**DATE:** June 14, 2017

**FROM:** Joint Utilities of New York – Interconnection Technical Working Group

**RE:** 05/10/17 ITWG Meeting Follow-Ups – JU Response to draft EPRI Report Questions

## GE Flicker Curve

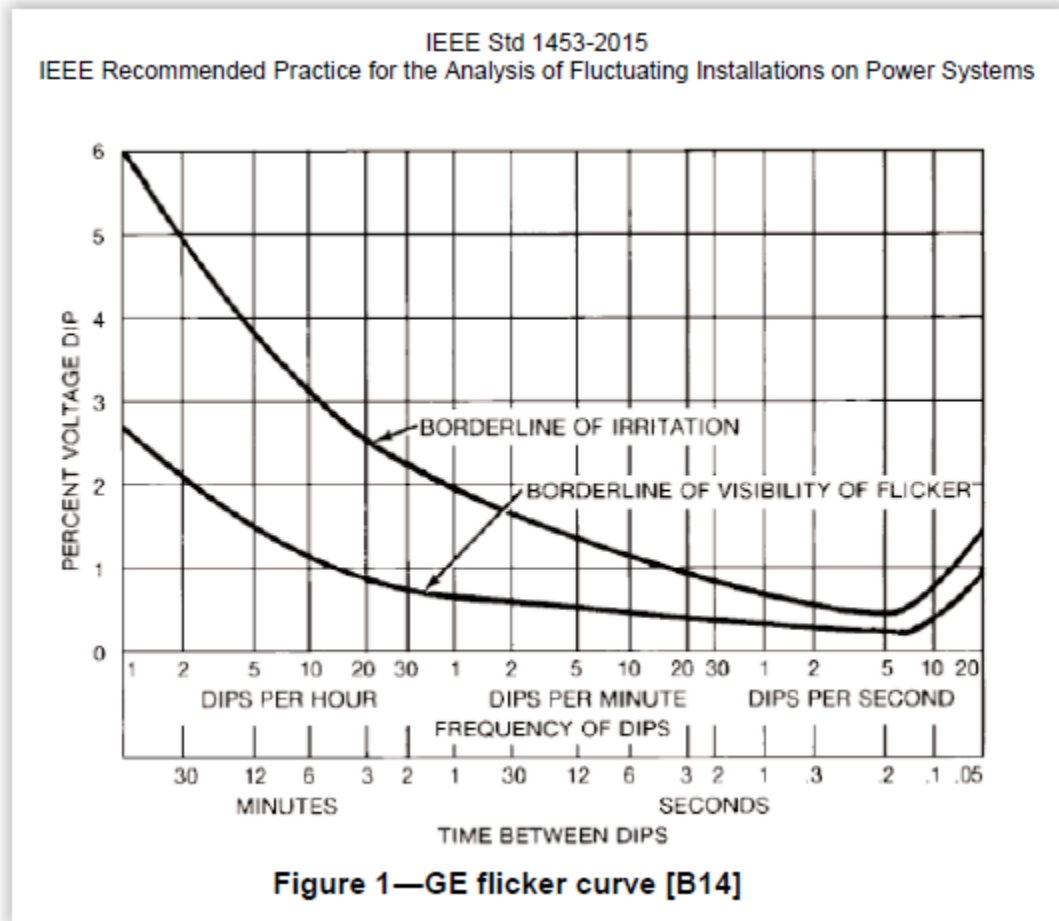
When applying the GE Flicker Curve as described in previous sections, each utility completes a load flow analysis on the proposed interconnection feeder and records the steady-state voltage during both peak and off-peak<sup>7</sup> load conditions at the point of interconnection. After the steady-state voltages have been recorded, the engineer then re-models both on and off-peak scenarios with the proposed DG operating at full nameplate capacity. This methodology provides the maximum possible voltage change by simulating if the DG were to go from operating at full nameplate capacity to zero across an instant in time. After the maximum percent voltage change is known, the utility compares the percent voltage change against the given time interval in the GE Flicker Curve. The aforementioned process is consistent across the JU; however due to inherent differences in utility service territories and planning criteria, the application of the GE Flicker Curve varies slightly between utilities, as shown in Table 1. For example, based on time between dips, and percent voltage dip, the utility could reach a different conclusion if they were to choose to use either the curve for borderline of irritation or borderline of visibility of flicker.
